ENGINEER'S CERTIFICATION FOR TEMPORARY C.O.

DRAINAGE PLAN AND **CALCULATIONS**

RECORD DRAWING

ONATE E.S. CLASSROOM BUILDING

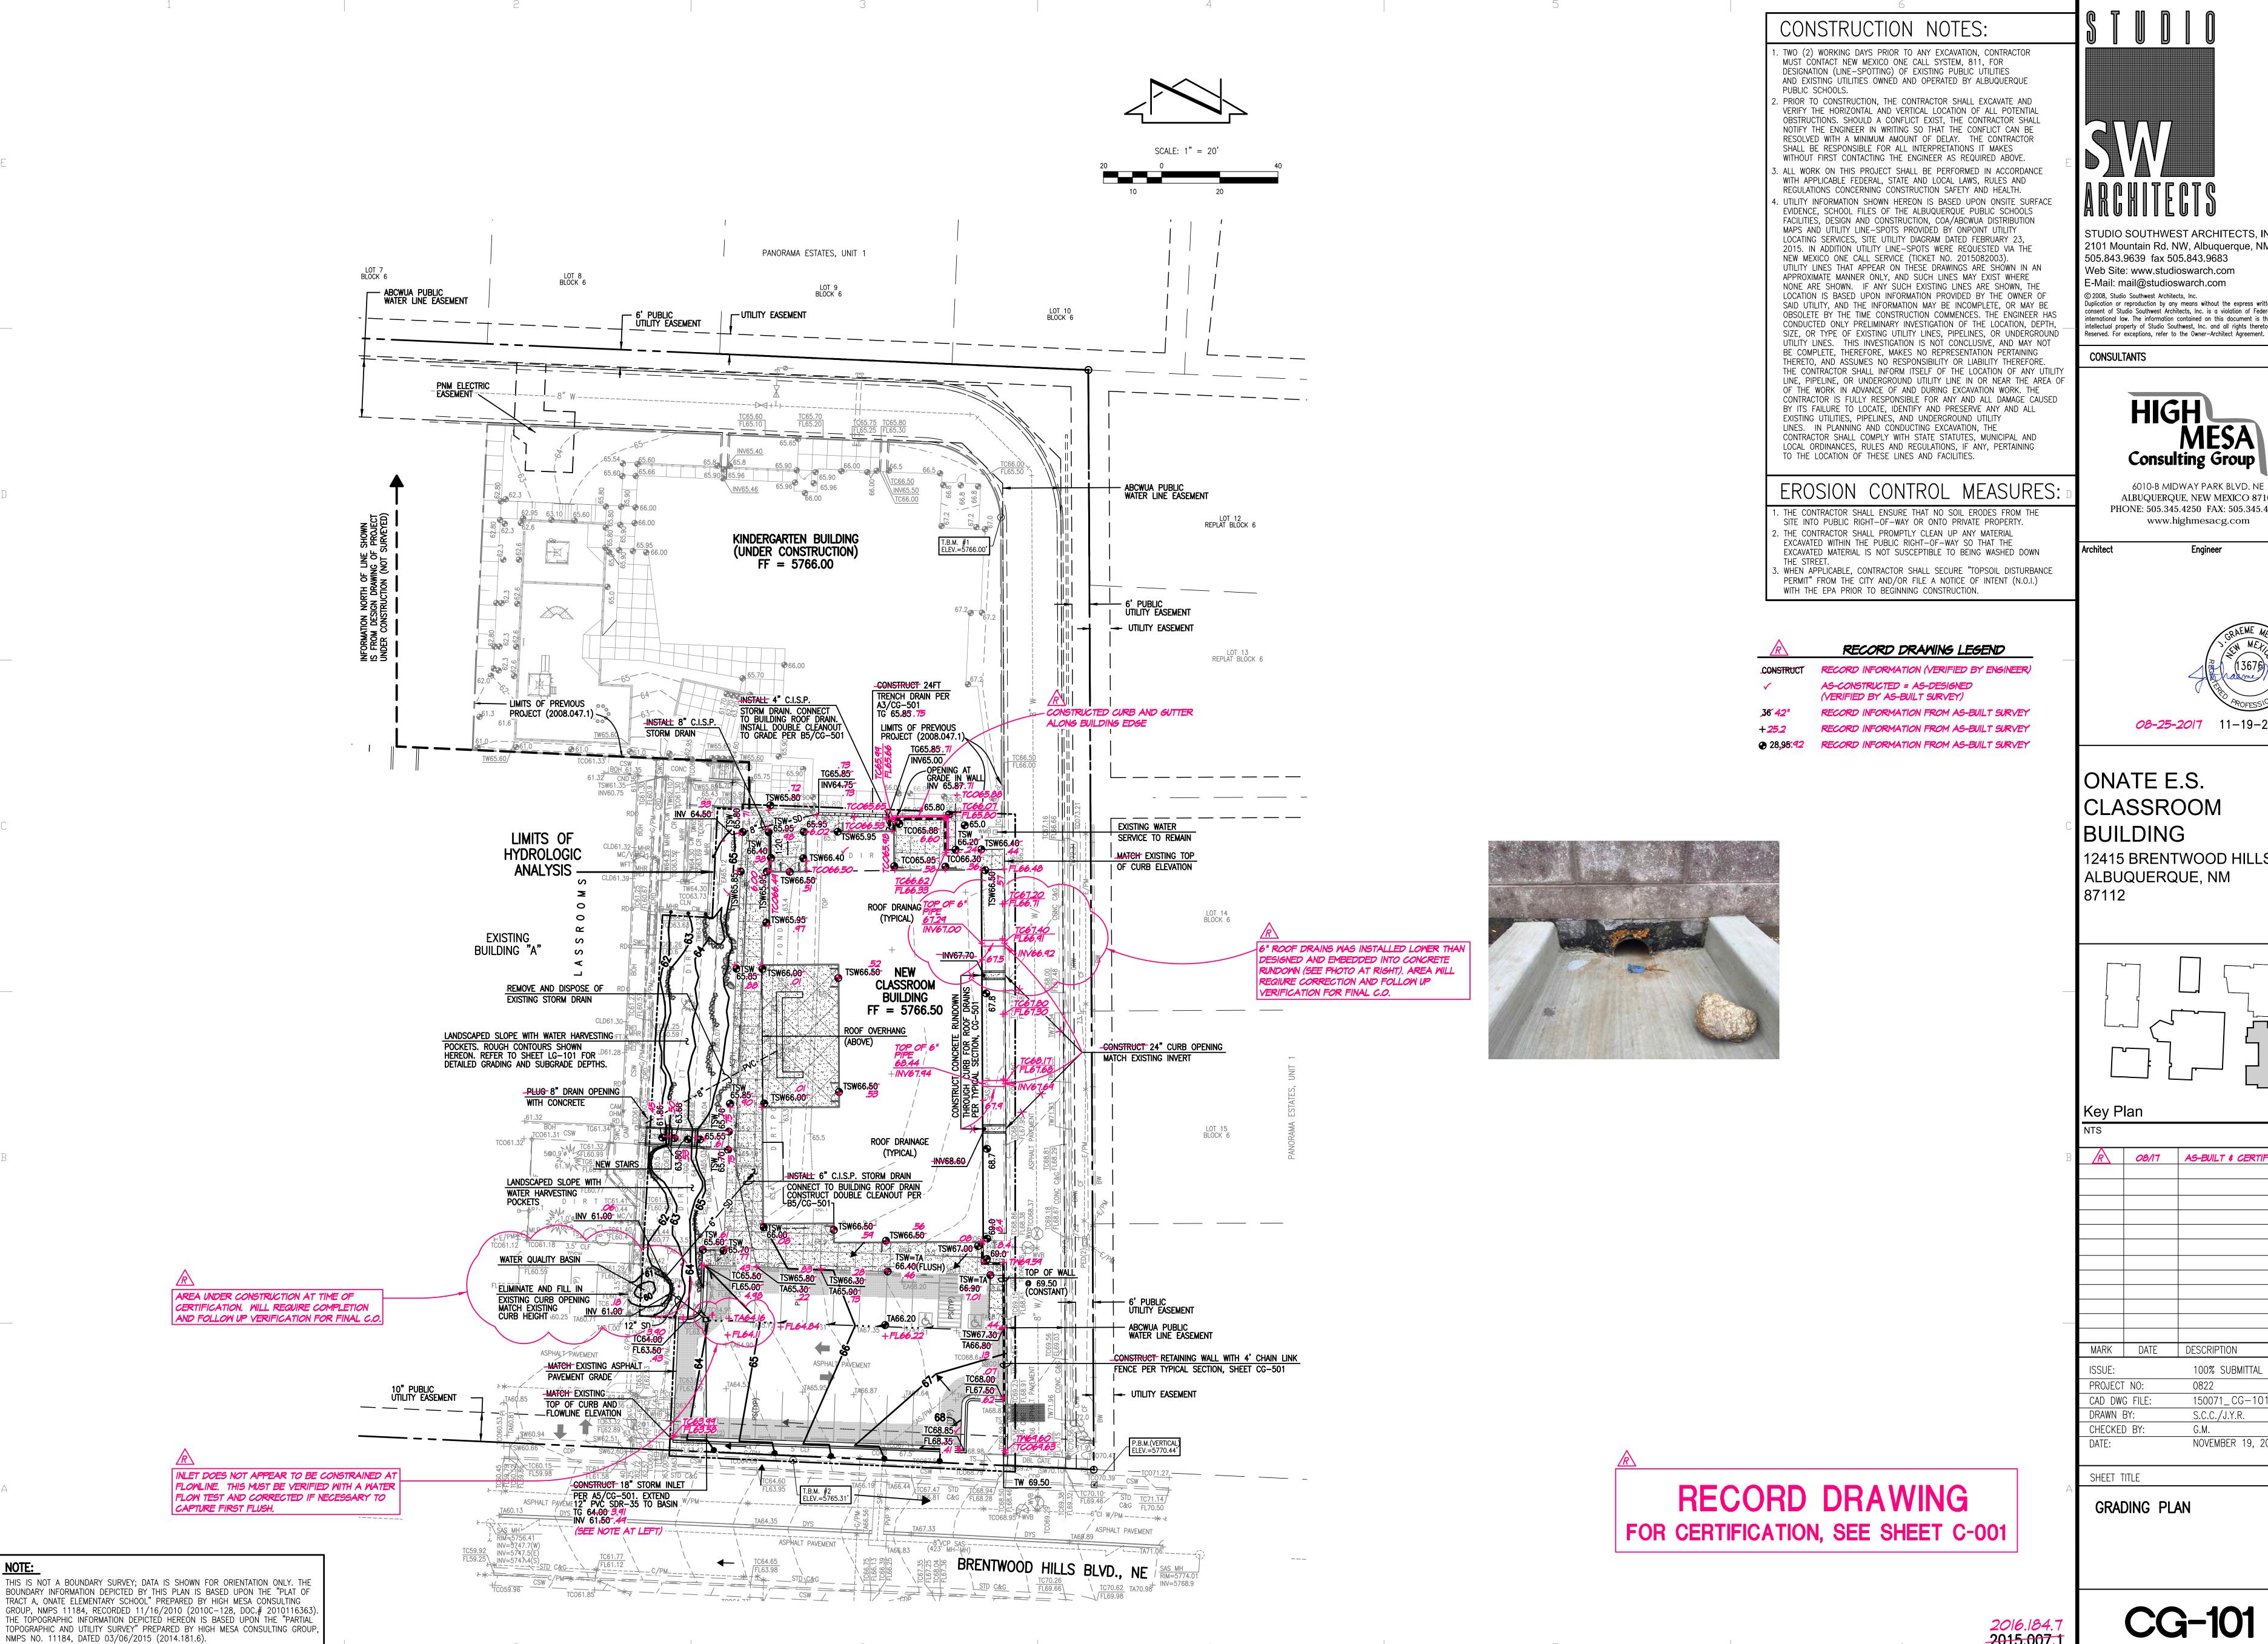
THE FOLLOWING ITEMS REQUIRE CORRECTION OR ADDITIONAL VERIFICATION PRIOR TO ENGINEER'S FINAL CERTIFICATION FOR PERMANENT CERTIFICATE OF OCCUPANCY:

THE SOUTHEAST WATER QUALITY BASIN AREA WAS UNDER CONSTRUCTION DURING TIME OF CERTIFICATION. THIS AREA WILL NEED TO BE COMPLETED PER

2) THE NORTHERNMOST 6" ROOF DRAIN LOCATED ON THE EAST SIDE OF THE BUILDING WAS INSTALLED LOWERED THAN DESIGNED AND EMBEDDED INTO THE CONCRETE RUNDOWN. THIS CONDITION WILL NEED TO BE CORRECTED TO NOT BE EMBEDDED WITHIN RUNDOWN AND STILL HAVE POSITIVE DRAINAGE TO THE ADJACENT ROAD. THIS WILL BE ACCOMPISHED BY CONSTRUCTING A NEW RUNDOWN THAT DISCHARGES TO A POINT APPROXIMATELY 24 FEET TO THE NORTH ALONG THE SIDEWALK.

THE EAST-WEST FLOWLINE IN THE SOUTH PARKING LOT LACKS DEFINITION AND IT DOES NOT APPEAR THAT PARKING LOT RUNOFF WILL BE CAPTURED BY THE INLET FOR FIRST FLUSH PURPOSES AS INTENDED. THIS AREA WILL BE FLOW TESTED AND IF NECCESARY WILL REQUIRE CORRECTION.

UPON CORRECTION OF THE PRECEDING, A VERIFICATION SURVEY AND CERTIFICATION

WILL BE PROVIDED FOR PERMANENT CERTIFICATE OF OCCUPANCY.
